[Docket No. FAA–2013–0725; Directorate Identifier 98–CE–01–AD; Amendment 39–17690; AD 98–15–18 R1]

Airworthiness Directives; Maule Aerospace Technology, Inc. Airplanes

ACTION: Final rule.

Figure 1

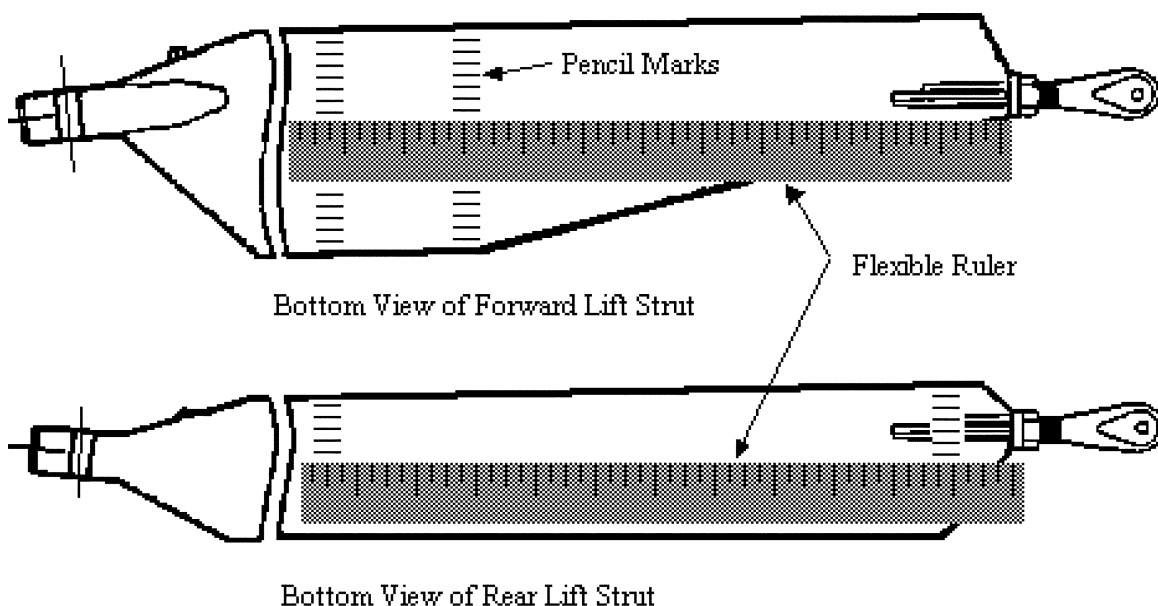
2. Using a flexible ruler, draw a 1/4-inch grid on the surface of the first 11 inches from the lower end of the strut as shown in Maule Air, Inc. Service Bulletin No. 11, dated October 30, 1995, as applicable. This can be done using a soft (#2) pencil and should be done on both faces of the strut. As an alternative to drawing a complete grid, make two rows of marks spaced every 1/4 inch across the width of the strut. One row of marks should be about 11 inches from the lower end of the strut, and the second row

should be several inches away where the strut starts to narrow. Lay the flexible ruler between respective tick marks of the two rows and use tape or a rubber band to keep the ruler in place. See Figure 1.
